ORIGINATION FORM

Proposed Revisions to a Standard Plans Index
(Please provide all information — Incomplete forms will be returned)

Index Number: 102-660
Sheet Number (s): 2 of 2
Index Title: Sidewalk Closure

LAST REVISION		DESCRIPTION:	 FY 2021-22 STANDARD PLANS	SIDEWALK CLOSURE	INDEX 102-660	SHEET 2 of 2
11/01/20	11/01/21

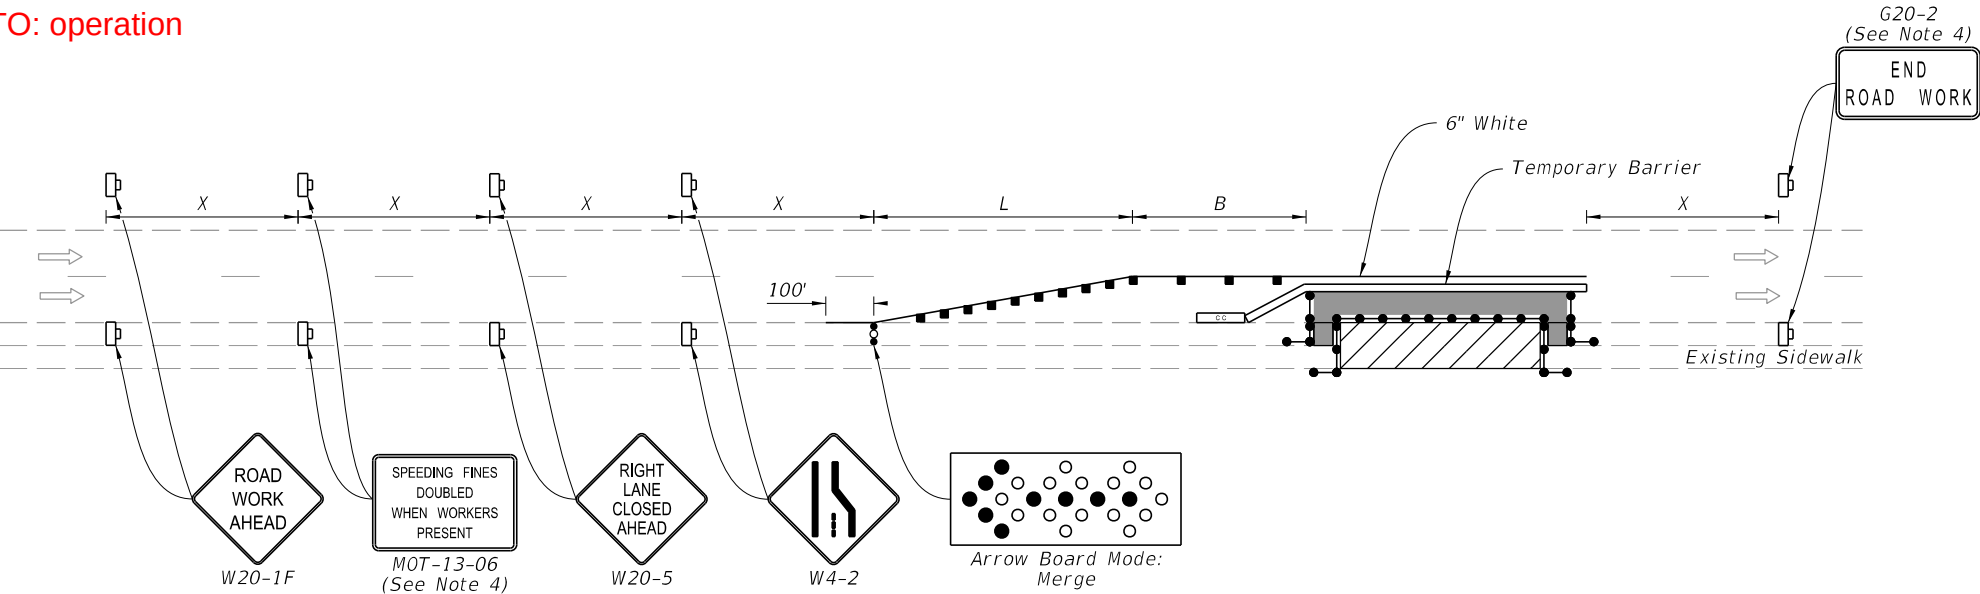
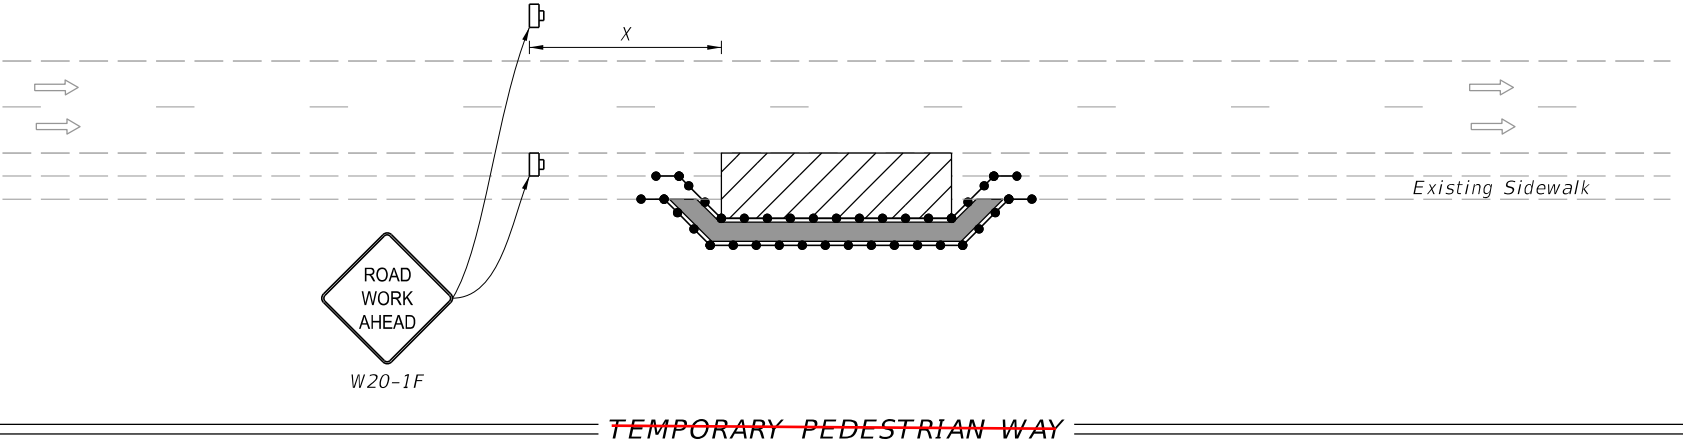
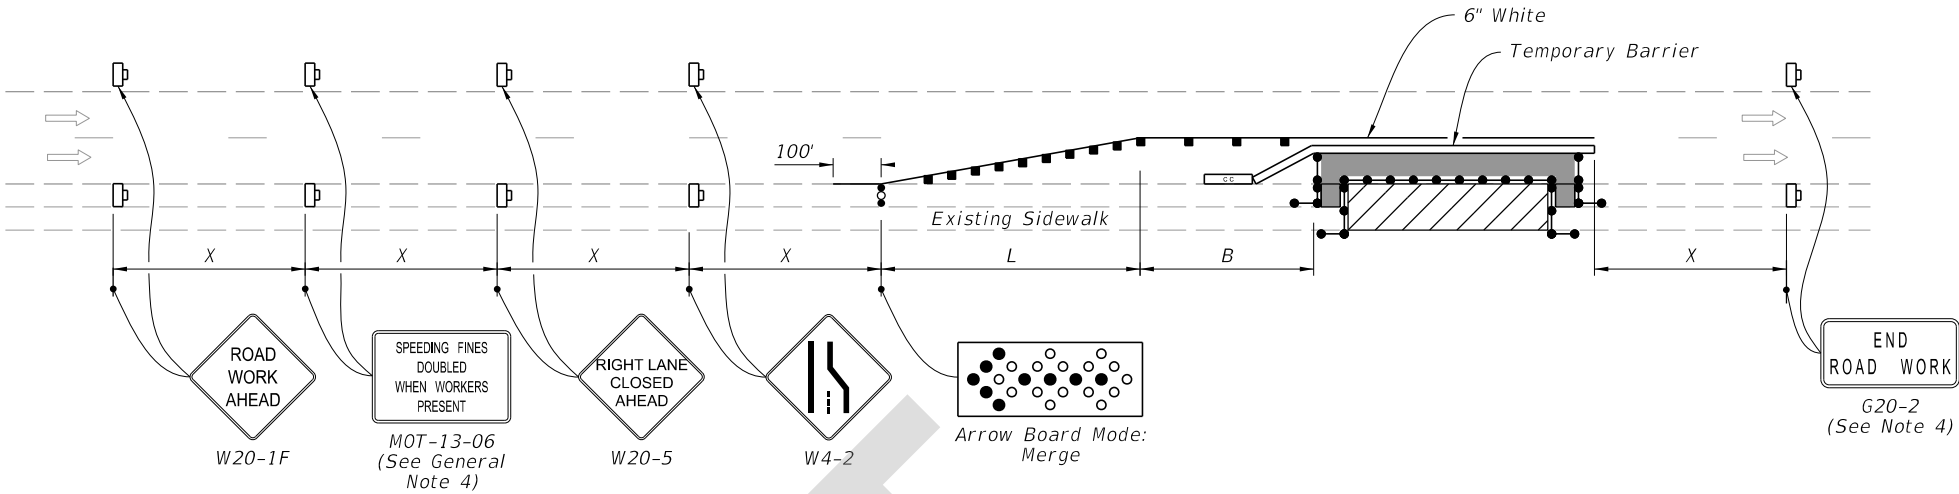
Sheet 2: Changed Note 4 - "work zone" to "work operations"; Added Note 5 - "Pedestrian Diversion may only be used when called for in the Plans or as approved by an Engineer."; Changed title "TEMPORARY PEDESTRIAN WAY" to "PEDESTRIAN SPECIAL DETOUR"; Changed title "TEMPORARY PEDESTRIAN WAY DIVERTING TRAFFIC INTO THE TRAVELED WAY" to "PEDESTRIAN DIRVERSION"; Added new detail "PEDESTRIAN DIRVERSION (Work Zone Speed 35 mph or Less).

ADDED NEW DETAIL:

CHANGED TO: PEDESTRIAN DIVERSION (Work Zone Speed 35 mph or Less)

5. CHANGED TO: operation

ADDED NOTE 5:
Pedestrian Diversion
may only be used
when called for in the
Plans or as approved
by an Engineer.

CHANGED TO: PEDESTRIAN DIVERSION

SHEET
2 of 2

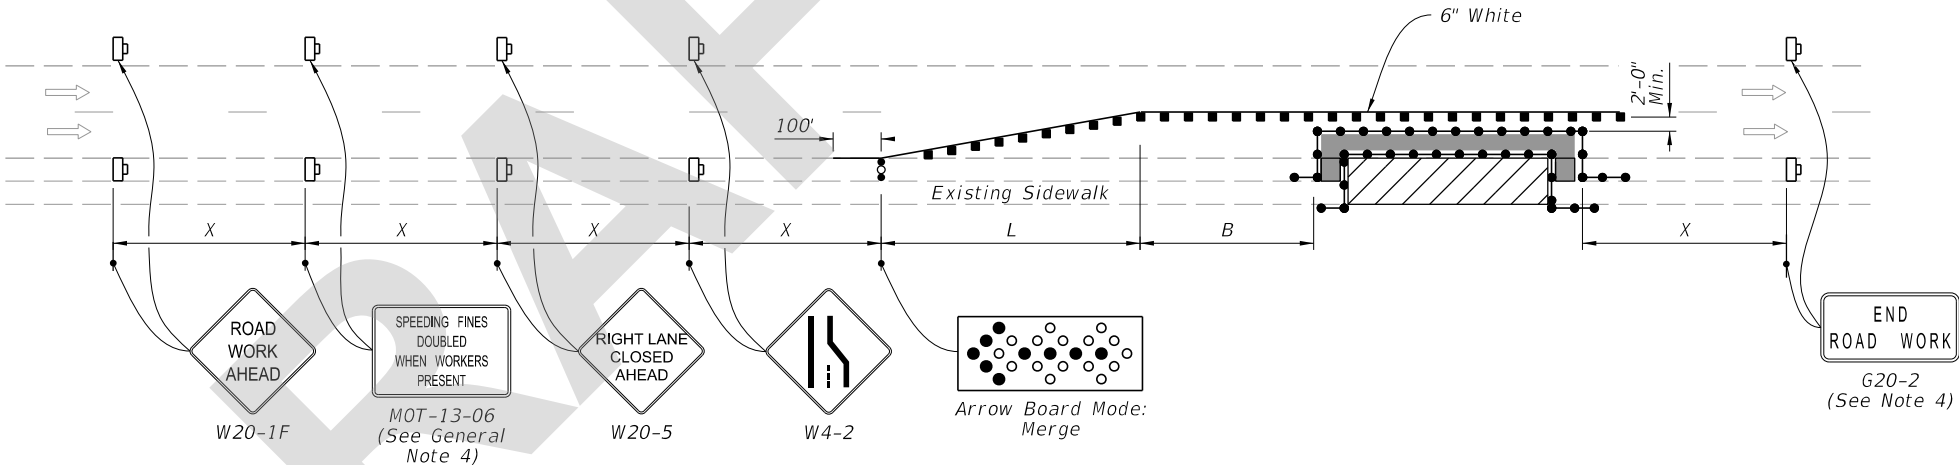
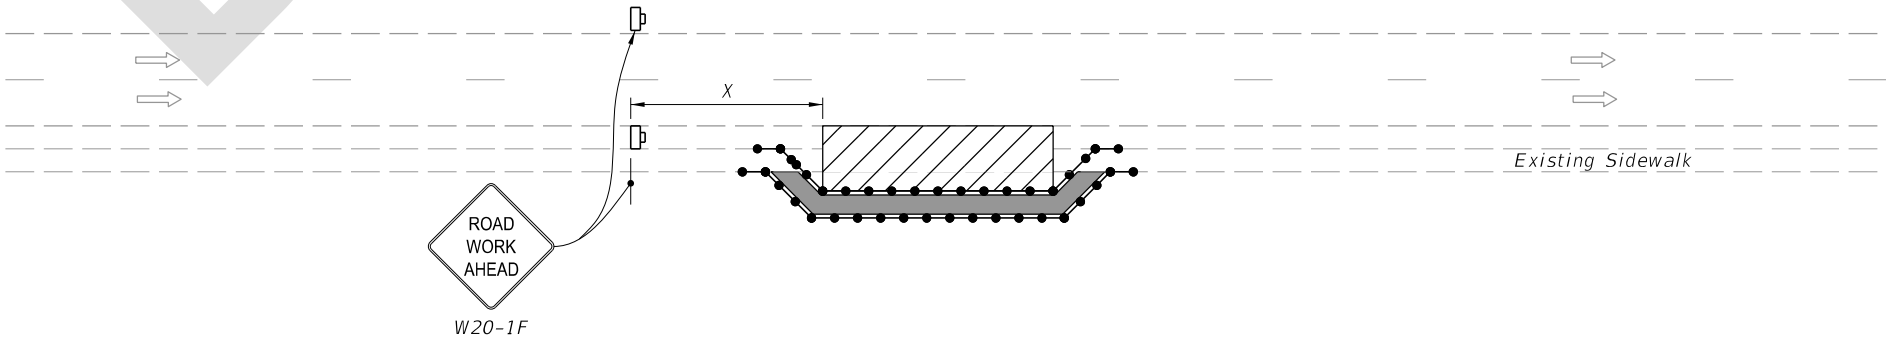
The duration provisions of the index are intended to apply to the length time needed to perform the specific temporary traffic control work "operation" shown, which is independent of the duration of an overall construction project. The term "Work Zone" is being replaced with "Work Operation" to clarify the intent.

5. Pedestrian Diversion may only be used when called for in the Plans or as approved by an Engineer.

PEDESTRIAN DIVERSION
(Temporary Barrier Shown, Low Profile Barrier Similar)

PEDESTRIAN DIVERSION
(Work Zone Speed 35 mph or Less)

PEDESTRIAN SPECIAL DETOUR
